PROPOSED TECHNICAL SPECIFICATION CHANGES

MANAGEMENT ORGANIZATION

POWER AUTHORITY OF THE STATE OF NEW YORK

INDIAN POINT 3 NUCLEAR POWER PLANT

FIGURE 6.2-1

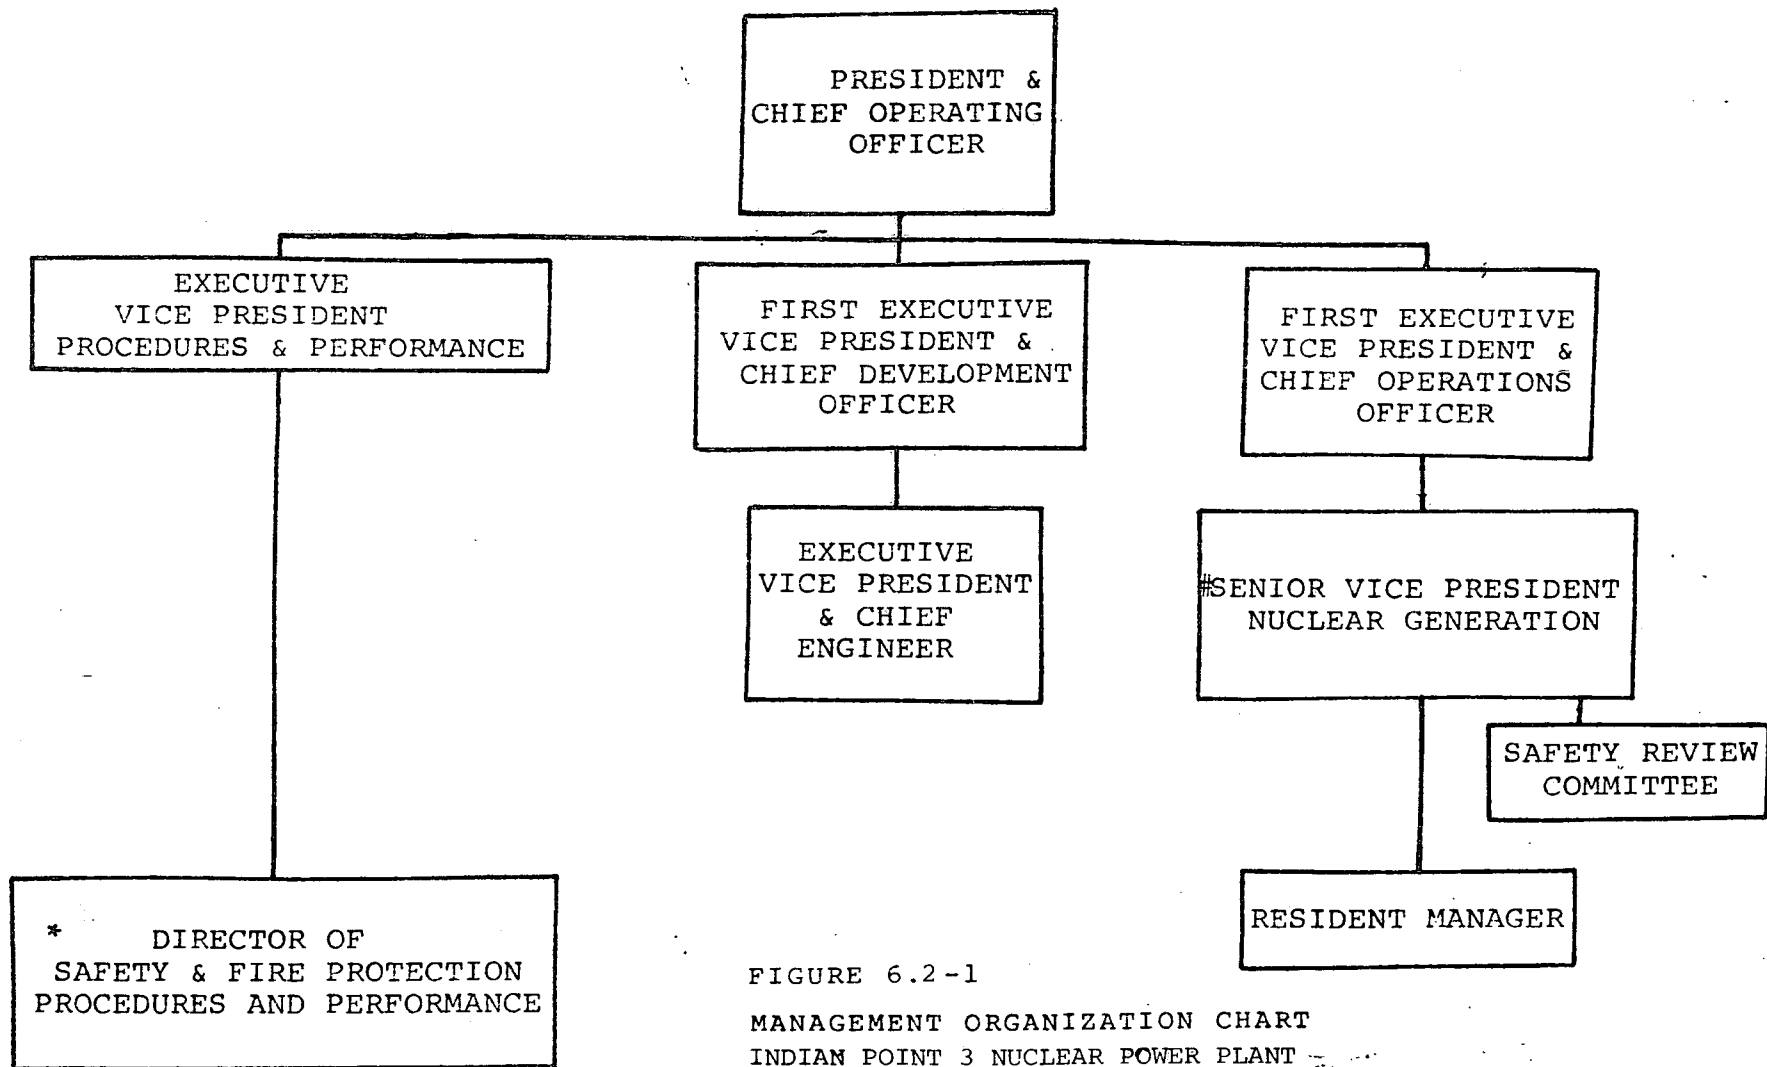
This proposed amendment to Appendices A and B of the Indian Point 3 Operating License (No. DPR-64) and James A. FitzPatrick Operating License (No. DPR-59) adds two new management positions to the organizational charts: First Executive Vice President & Chief Development Officer, and First Executive Vice President & Chief Operations Officer.

Both figures, contained in Appendices A and B of each facility's Technical Specifications, entitled respectively "Management Organization Chart" (Fig. 6.2-1 on page 6-2 of IP-3 TS and Fig. 6.1-1 on page 259 of JAF TS) and "Management Organization - Offsite Radiological Environmental" (Fig. 5.2-2 on page 5-8 of IP-3 TS and Fig. 5.2-2 on page 44 of JAF TS) have been revised to show these two new positions.

FIGURE 6.2-2

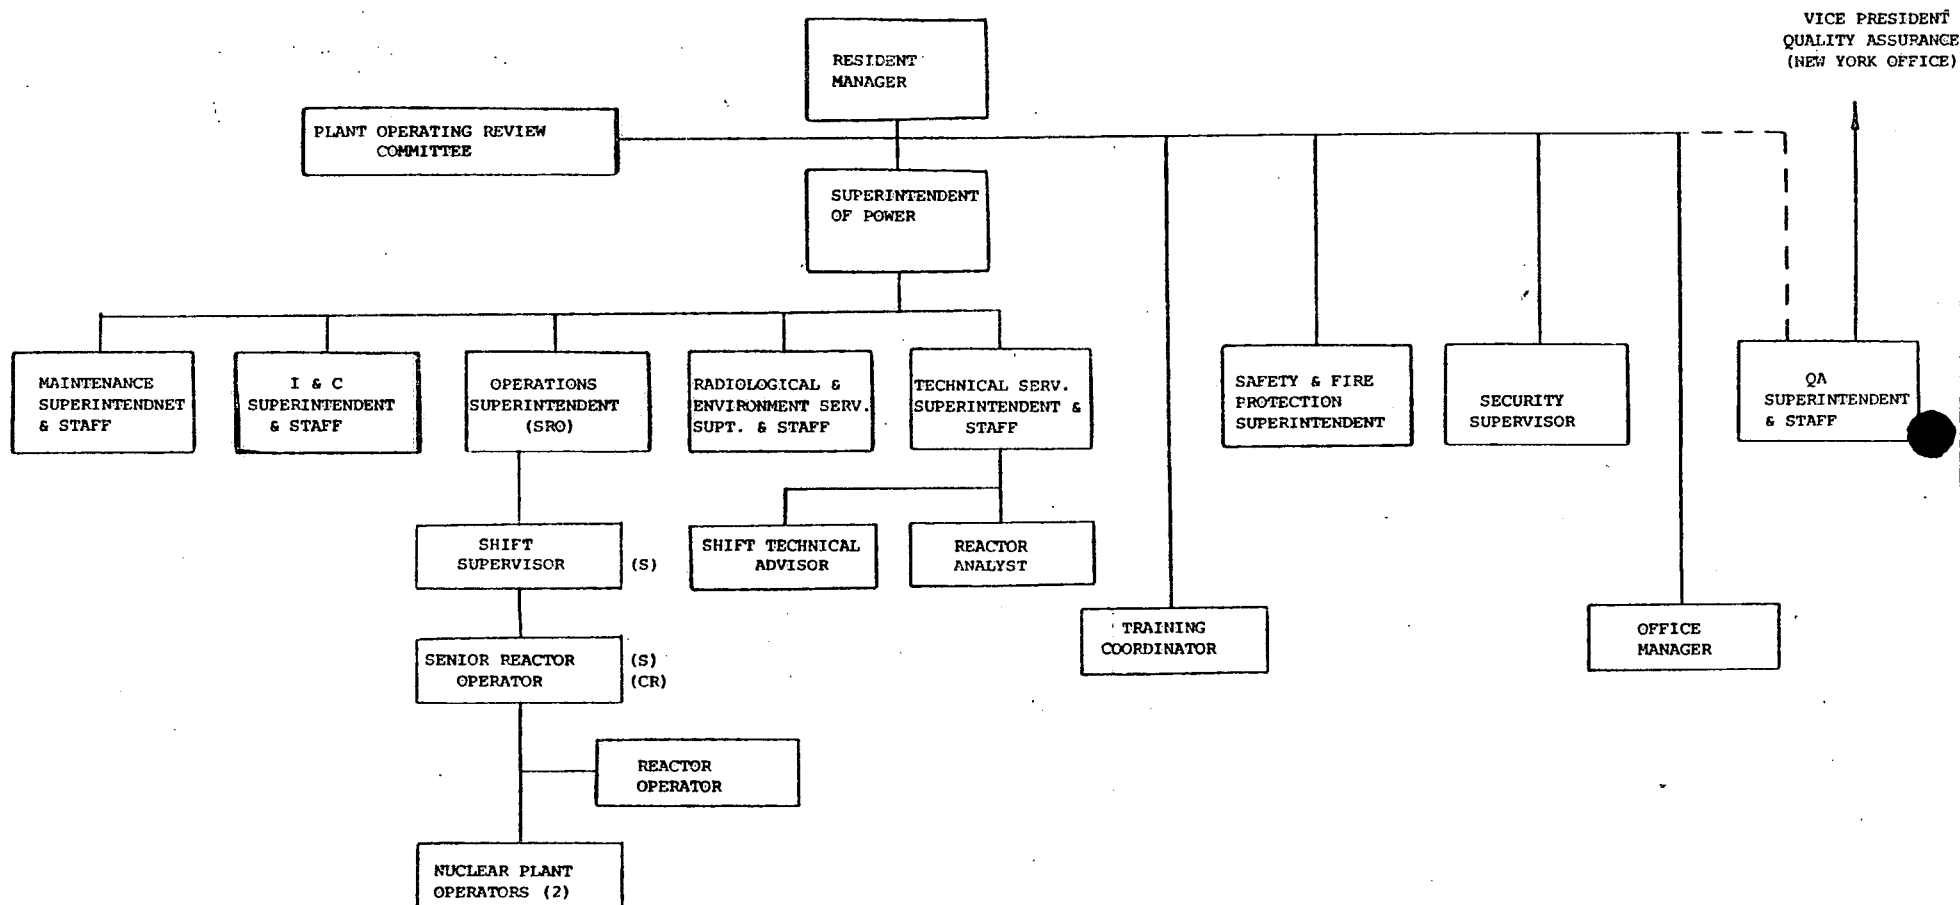
In addition, Figure 6.2-2, "Plant Staff Organization" on page 6-3 of Appendix A to the IP-3 TS has been revised to show the division of the Security and Safety Superintendent position into two separate positions: Security Supervisor and Safety and Fire Protection Superintendent.

For the Indian Point 3 Nuclear Power Plant the position of Security and Safety Superintendent is proposed to be separated into a Security Supervisor and a Safety and Fire Protection Superintendent. The creation of the Security Supervisor position will allow the Safety and Fire Protection Superintendent to concentrate more extensively on the plant's safety and fire protection programs. Both positions will report to the Resident Manager.
